[Docket No. FAA-2023-1814; Project Identifier AD-2023-00773-T; Amendment 39-22541; AD 2023-17-14]

Airworthiness Directives; The Boeing Company Airplanes

Final rule; request for comments.

Figure 1 to paragraph (h)(4) – Cap seal minimum thickness (all dimensions in inches)

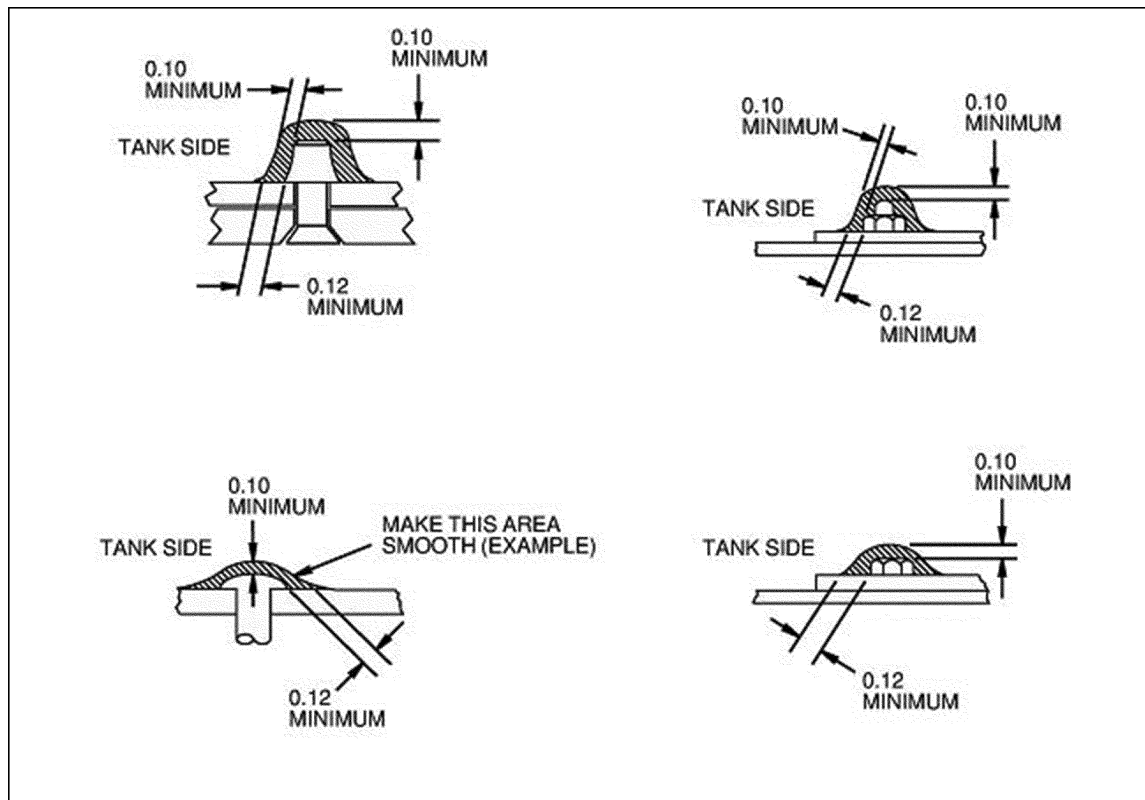
(4) During application of any cap seal to a fastener, fastener head, and fastener threads and collars, as required by this AD, the cap seal must be applied with a thickness equal to or greater than the dimensions specified in figure 1 to paragraph (h)(4) of this AD.

(6) Where Boeing Alert Requirements Bulletin 777-57A0122 RB, dated October 8, 2021, requires inspections that may require the removal of fastener cap seals, this AD requires that if the cap seal is removed, a cap seal of BMS 5-45 sealant be reapplied with a thickness equal to or greater than the dimensions specified in figure 1 to paragraph (h)(4) of this AD before further flight after completion of the inspection.

(ii) All cap seals were applied using procedures with thickness dimensions greater than or equal to those given in figure 1 to paragraph (h)(4) of this AD.
